Re: The application of Homeland Towers, LLC, New York SMSA Limited Partnership d/b/a Verizon Wireless and New Cingular Wireless PCS, LLC ("AT&T") collectively (hereafter "Applicant") to construct a wireless telecommunications facility at 15 Rockledge Road, Village of Nelsonville, New York (41° 25' 20.32"N, 73° 56' 27.56"W).

Review of Methodologies for Visual Resource Assessment: Nelsonville, NY (Homeland Towers LLC application)

Photo source: Saratoga Associates VRA – VP11:
Cold Spring Cemetery (near historic Gatehouse) – "Figure 5b"

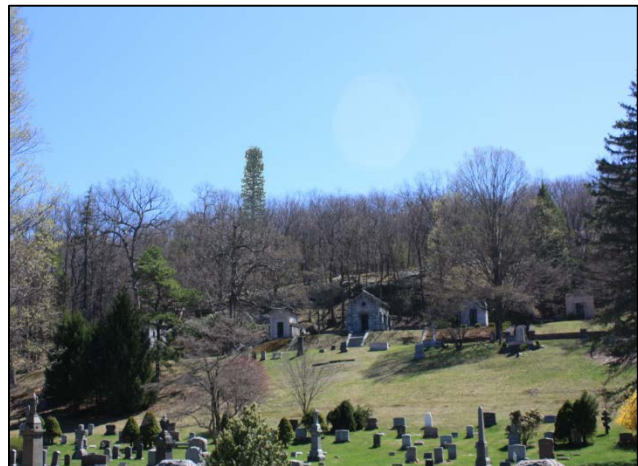
- The vertical height of the proposed tower (110 feet) will be inconsistent with the average height of most of the forest trees that encompass the landscape vegetation along the valley's hillside (<75 feet). The visual rendering in the Saratoga Associates VRA (see image right) clearly depicts this, which is misaligned with the best design principles outlined in the Planning and Design Manual for the Review of Applications for Wireless Telecommunications Facilities (see Appendix V.b).
- Additionally, the proposed removal of trees (JMC drawing entitled: TREE REMOVAL PLAN, ZD-4, dated 07/11/2017) would leave a distinct scar upon the vegetative character of the hillside landscape. This site-based impact is not portrayed in the VRA photo simulations, nor is it revealed in the statements made when referring to the visual impacts of the tower.

Photo source: Saratoga Associates VRA – VP12:
Cold Spring Cemetery (north end) – “Figure A7”

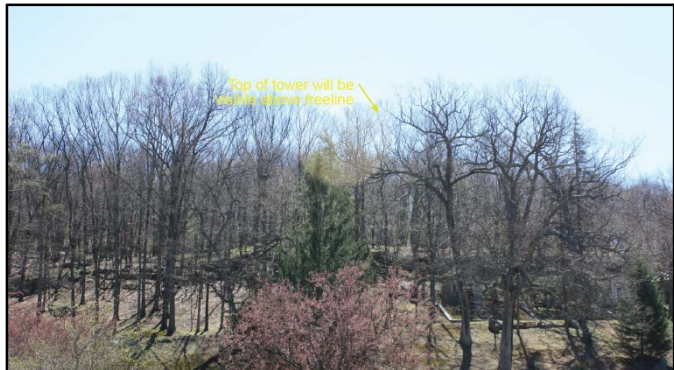
- This property is of very significant value both on the national level (National Register of Historic Places - NRHP) as well as at the community level, being designated as one of many areas of cultural and scenic importance. Coincidentally, this cemetery site would receive the most impactful view of the proposed tower due to its proximity and unimpeded sight-lines.
- The VRA's photo simulations provide representations of the cemetery from the two identified vantage points of the viewshed analysis. However, by simply providing two main photos with only one demonstrating an actual rendering of the proposed tower, the minimum requirements to complete a VRA for the simulation/visualization section *might* be satisfied, but additional renderings would most likely need to be submitted in order to appease the obligation of providing sufficient evidence of minimal impact.

- Proof of minimal disturbance of the cemetery site during construction (noise, runoff, equipment placement/travel, etc.) was not provided in the Applicant's submission package.
- Specifically, the cemetery's Gate House building is a listed property on the NRHP. However, the entire cemetery was deemed 'eligible' for the Register by New York's State Historic Preservation Office (NY-SHPO). Additionally, the area of potential visual impact for the proposed tower site contains 13 individually-listed properties on the National Register, which amounts to a very high concentration of historically-significant properties within a ½-mile radius of the proposed 110-foot tower.
